WIRING CONNECTIONS FOR A-M-1 FLASHER, PART NO. 68542-58

HARLEY-DAVIDSON MOTOR COMPANY
MILWAUKEE 1, WISCONSIN, U.S.A.

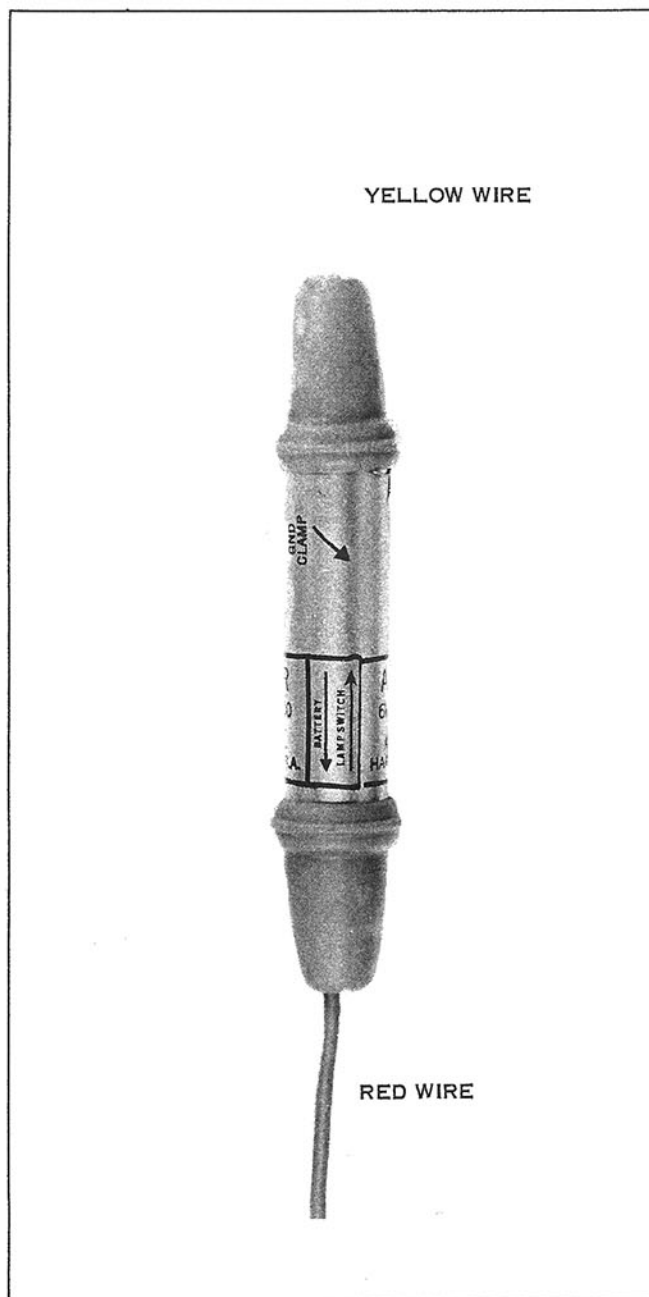
Correct hook-up for this flasher is specified on the installation instructions supplied with each kit. Markings on flasher indicating battery and switch connections should be disregarded, since they do not apply to motorcycle installations.

The RED wire must be connected to the source of current with a switch in series. On directional lamp installations it must be connected to a terminal plate post that is live only when the ignition switch is on. On pursuit lamp installations it must be connected to a terminal plate post which is live only with handlebar switch on.

Do not connect the RED wire direct to the battery or to a terminal which is live at all times, because this type of flasher is grounded and draws a small amount of current in this case.

Some cases have been reported where the flasher red wire has been connected by mistake to a terminal which was live at all times. The accompanying constant current drain through the flasher ground circuit has caused a dead battery in motorcycles not operated daily.

IMPORTANT: If there is a special installation where the flasher is used to operate a flashing light, an extra switch must be inserted between the flasher and the battery or live terminal so that the flasher ground circuit is broken when the light is turned off.

CAUTION: Even though the lamp or lamps to be lighted through the flasher may have built-in switch, the extra switch is to be connected in series with red wire and must be turned off when the motorcycle is not operated.
